Design Change

3768 & 4768 series

Hinge Handle 3/8" & 1/2"

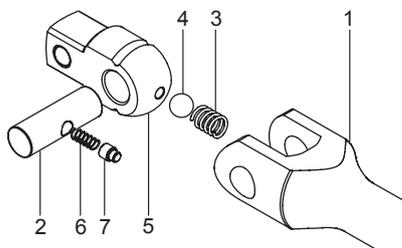
This design change has been made to all 3/8", 1/2" Hinge Handles and Renewal Kits.

Retaining Groove and hole allow square drive to be held in straight and right angle positions.

Fitting traditional renewal kit was always frustratingly difficult. The new renewal kits are extremely easy to fit with no drilling of the pin holding the square drive required.

The new kits can also be fitted to the traditional models but the old pin must still be drilled and punched out.

To disassemble, the pin can easily be removed by inserting a wire through the retaining hole in the base of the square drive to depress the plunger holding the pin in place.
